| Well Name: HAWK 9B FEDERAL     | Well Location: T18S / R27E / SEC 9 / NWNE / | County or Parish/State: EDDY / NM |

**Notice of Intent**

Type of Action: Plug and Abandonment

**Plug Abandonment  
NOI Proposed**

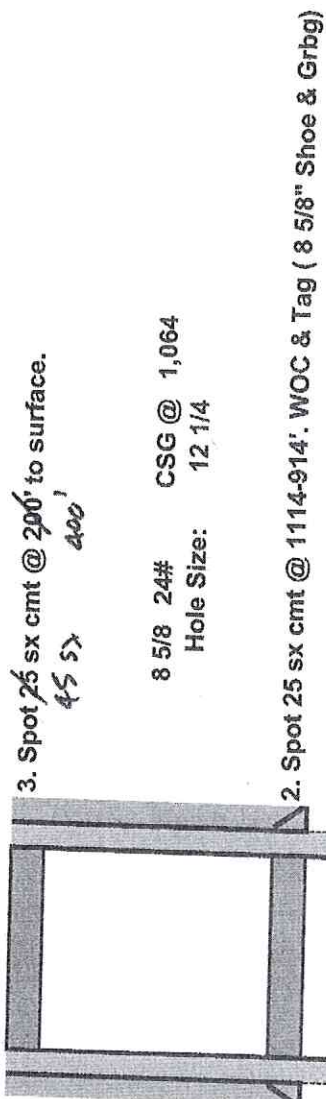
1. Set 5 1/2" CIBP @ 1760'. Circ hole w/ MLF. Pressure test csg. Spot 25 sx cmt @ 1760-1560'.
2. Spot 25 sx cmt @ 1114-914'. WOC & Tag ( 8 5/8" Shoe & Grbg)
3. Spot ~~25~~ sx cmt @ 200' to surface. 400' to surface 45 sx
4. Cut off well head, verify cmt @ surface. Weld on Dry Hole Marker.
